HOPE CREEK GENERATING STATION
DOCKET NO. 50-354
FSAR COMMITMENT STATUS THROUGH MAY 1984

ATTACHMENT I
HOPE CREEK GENERATING STATION
FSAR COMMITMENT STATUS THROUGH MAY 1984

FIGURE 430.145-1

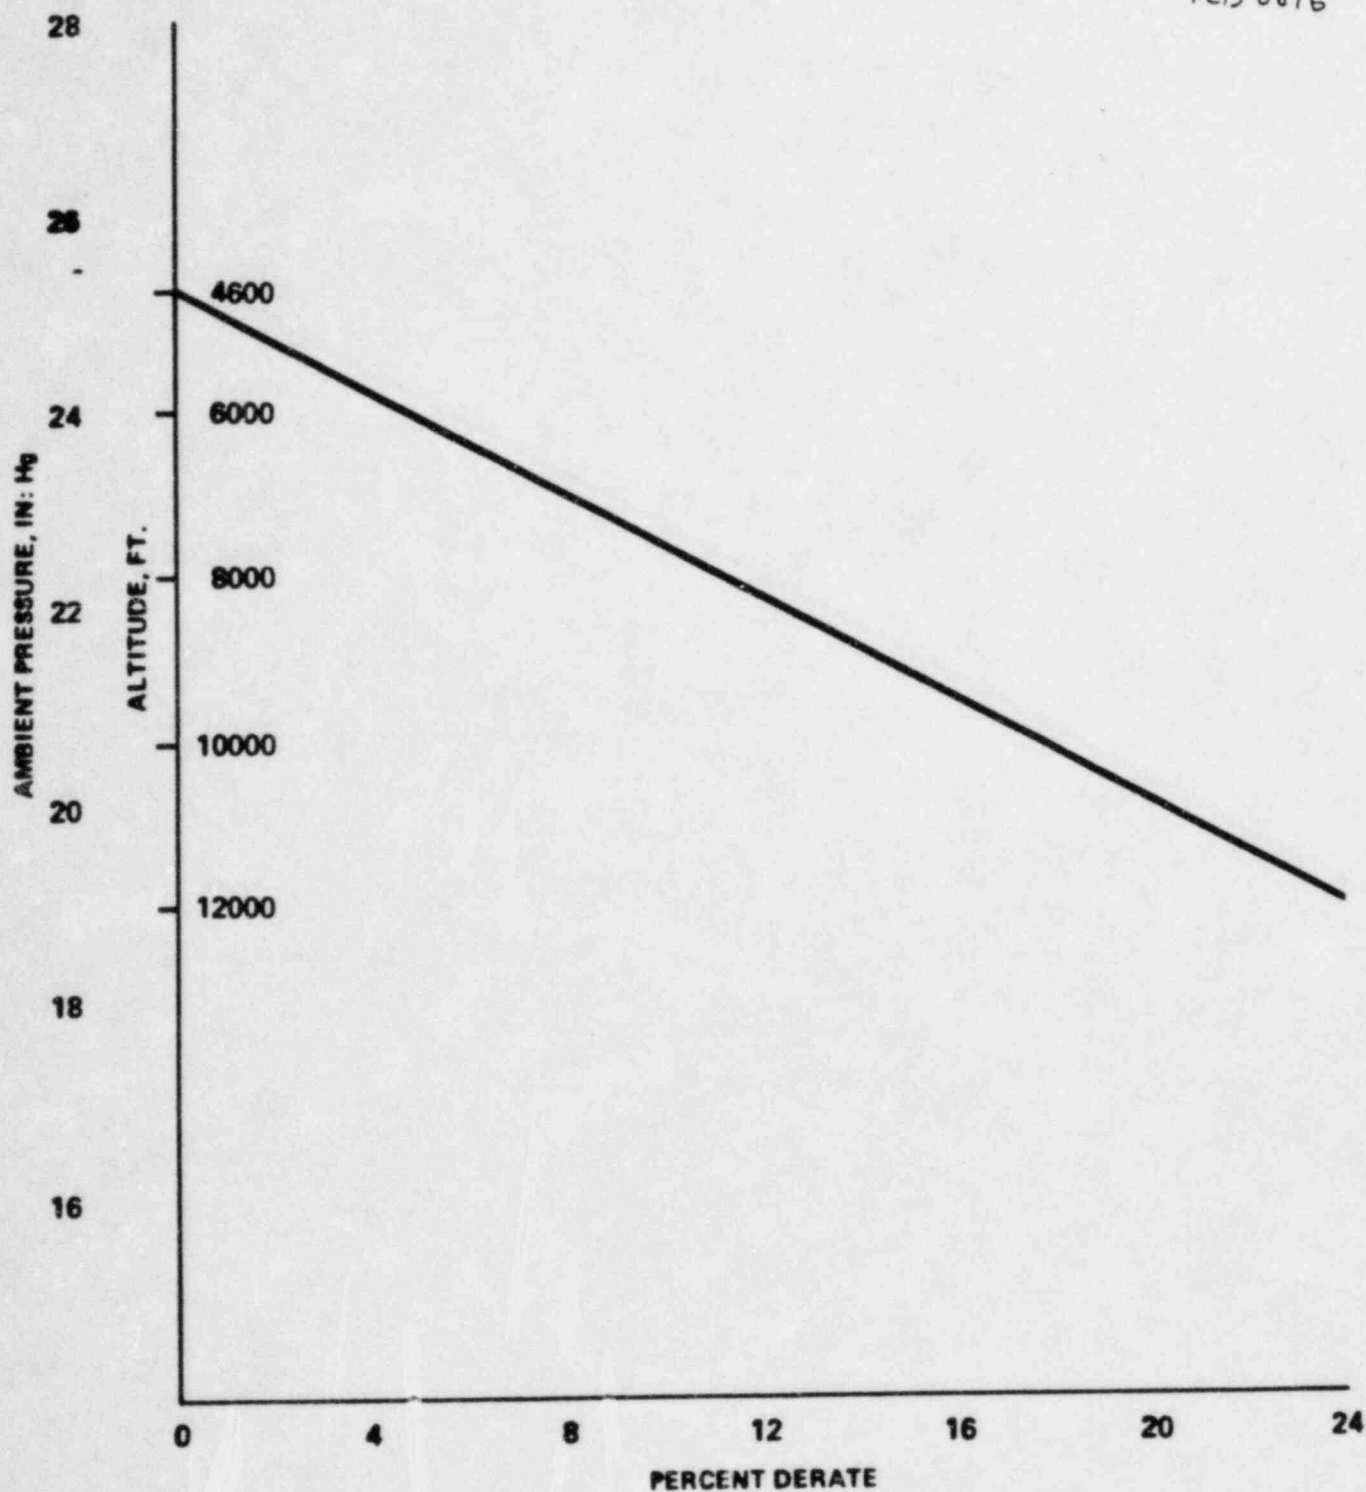
- d. Provide the manufacturer's design data for ambient pressure vs engine derating.
- e. Discuss the effects of any other service and weather conditions will have on engine operation and output, i.e., dust storm, air restriction, etc.
(SRP 8.3.1, Parts II & III; SRP 9.5.5, Part III, SRP 9.5.7, Parts II & III; and SRP 9.5.8, Parts II & III)

- d. A curve of the 12CR.PC2 class engine derating for ambient pressure (altitude) is attached (Figure 430.145-1). It should be noted that this curve is applicable on the long term basis - altitude derating - and is not applicable to short term phenomena such as tornadoes, hurricanes, tropical storms, or other weather depressions.
- e. The diesel engine manufacturer confirms that as long as the unit is adequately maintained (air intake filters kept cleaned, etc), there are no other conditions adverse to the engine.
